**CITY OF LOMPOC
PLANNING COMMISSION STAFF REPORT**

MEETING DATE: MAY 27, 2009

RE: SANTA RITA HILLS WINE CENTER–
ENVIRONMENTAL IMPACT REPORT – EIR 08-02
GENERAL PLAN AMENDMENT – GP 08-01
ZONE CHANGE – ZC 08-01
TENTATIVE PARCEL MAP – LOM 582
DEVELOPMENT PLAN – DR 08-01

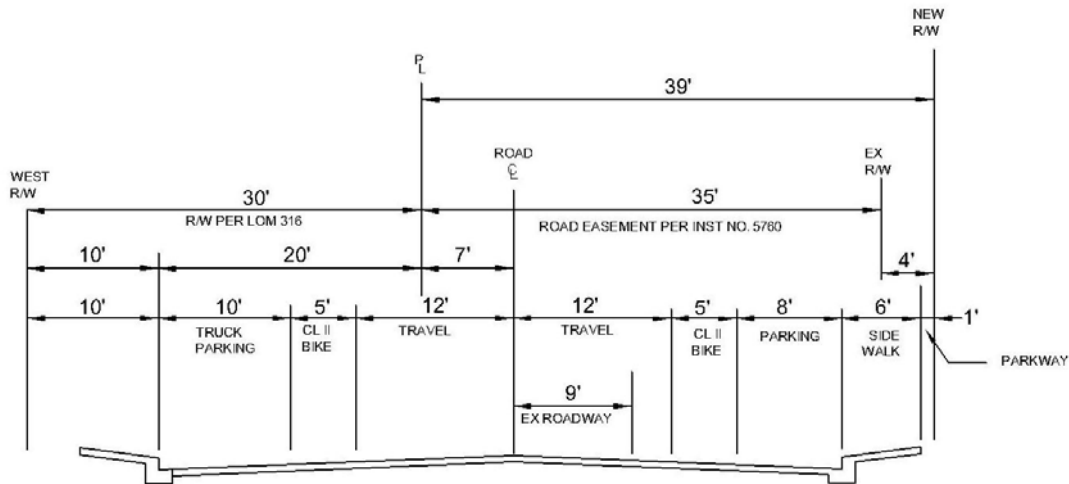
- EN35. All on-site retardation basins shall be lined with an impervious clay-layer to prohibit infiltration.
- EN36. A shared driveway designed to serve both this development and the River Terrace development shall be provided at the entrance in the northwest corner of the project in lieu of the driveway entrance shown on the development plan. The shared driveway shall be

centered on the construction centerline of Laurel Avenue or located such that the traffic exiting the proposed development will align with westbound Laurel Lane.

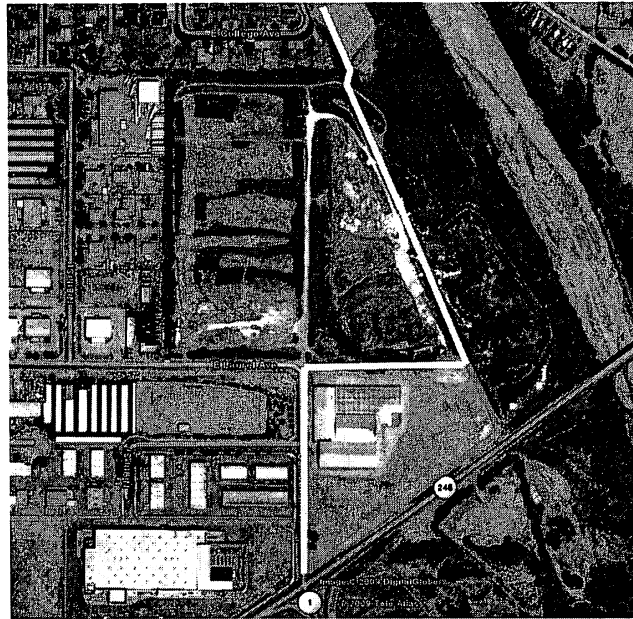
There is one design element to which I take exception. The Transportation and Circulation which discusses found no impact. I disagree. The project proposes a class II bike path along 12th street on the project's western side. [4.6-7] This bike path would be crossed by 3 or 4 driveways depending on the final plan circulation plan adopted. Two of the driveways would be used primarily by truck traffic. Add that trucks would be backing into the warehouses on 12th near Industrial way. These hazards could all be avoided if the bike path were located along the eastern property line from the River Terrace site to Ocean. This is a logical extension of the bike path will be built as part of River Terrace.

The air photo to the right shows in green the Class 1 bike path that will be installed as part of the River Terrace project. As suggest now in the current plan in the bike path will continue along the yellow line. My suggestion is for the bike path to continue along the blue line. This would keep the path as class 1 all the way to the Hwy 1 intersection and reduce the number of crossings and potential hazards. This would also keep the path along the river longer rather than going between houses and warehouses as currently proposed.

Mitigation Measure 4.8-12:

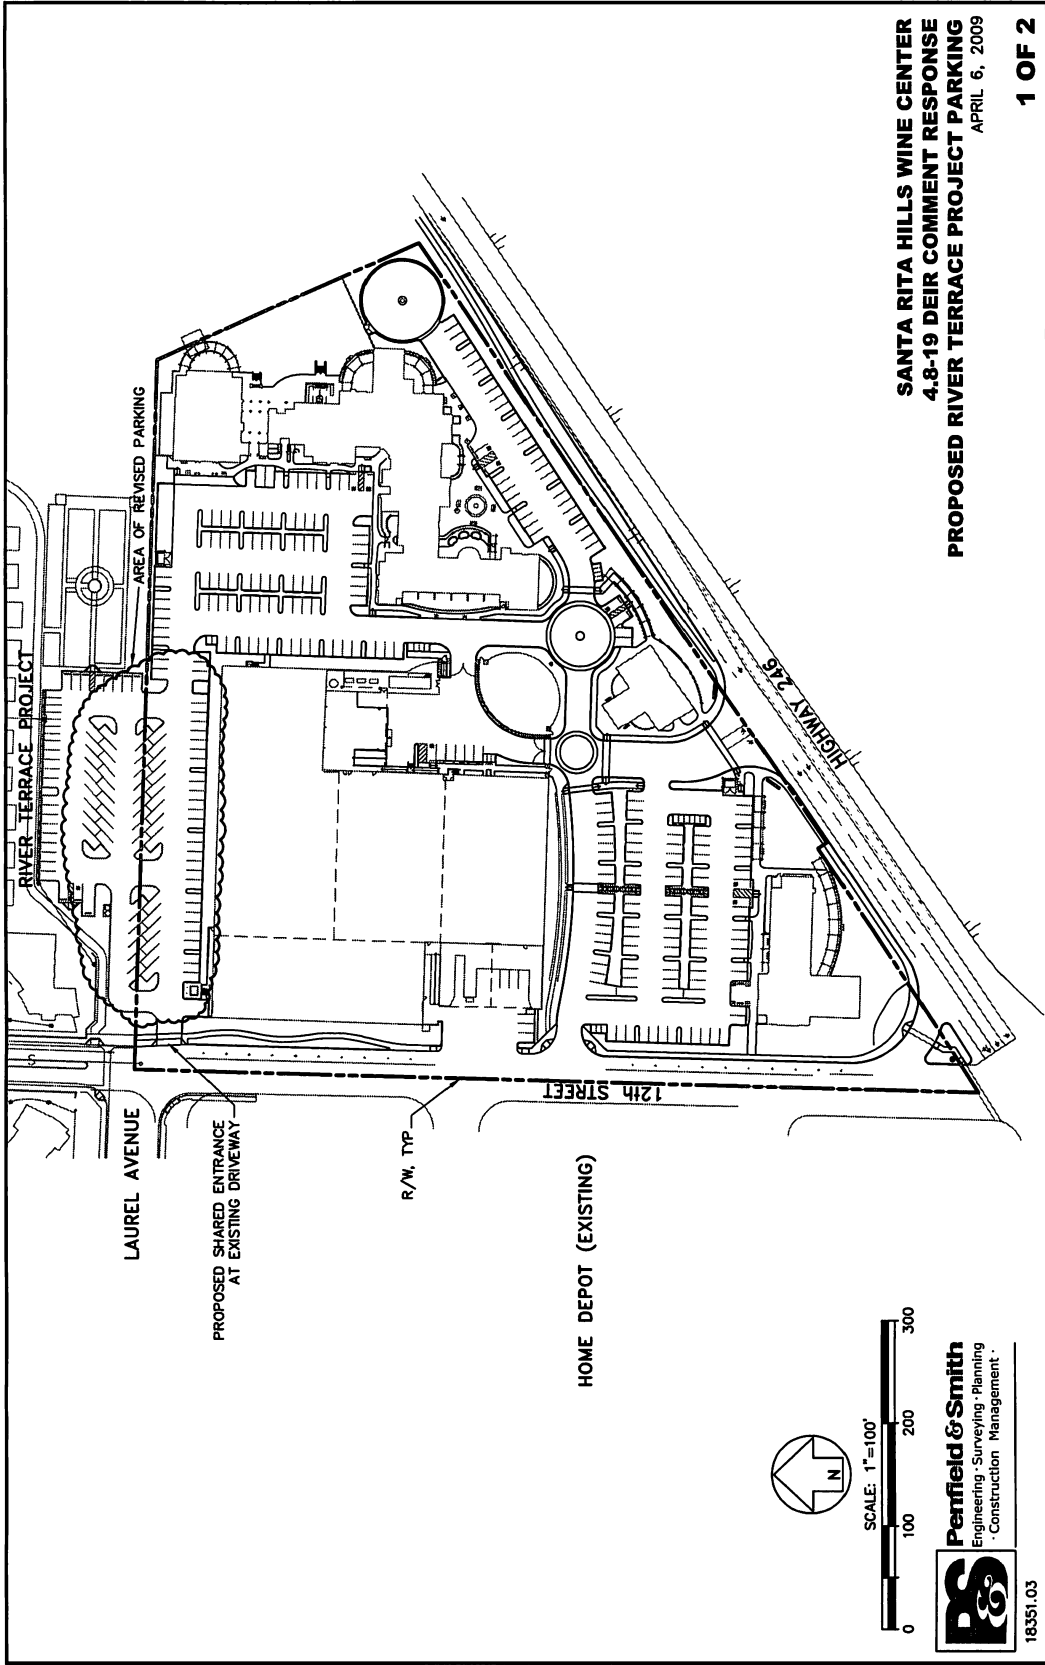
The site entrance will be modified to accommodate a two-way left turn lane between 12th Street and the Highway 246 entrance to the project. Per the Caltrans comment letter dated April 1, 2009, this two-way left turn lane will extend beyond the main access far enough to accommodate the storage of two exiting passenger cars turning left out of the driveway. A taper will then be provided to transition back to the existing highway striping. It should be noted that the two-way left turn lane will be designed in accordance with Caltrans Standard Specifications, but that the full width of the TWLTL will not extend along the entire frontage of the project. See the attached "4.8-10 Highway 246 Proposed Striping" Exhibit.

"Caltrans STAA trucks shall be restricted to the external loading dock on 12th Street. Trucks with AASHTO 1990 SU dimensions or smaller can safely perform all turning movements at the main access driveway on Highway 246 and the second (southern) access driveway on 12th Street. On-site circulation of the smaller (AASHTO 1990 SU dimensioned) trucks shall be limited to the drive aisles between the main access driveway on Highway 246 and the internal loading dock and the second (southern) access driveway and the internal loading dock."
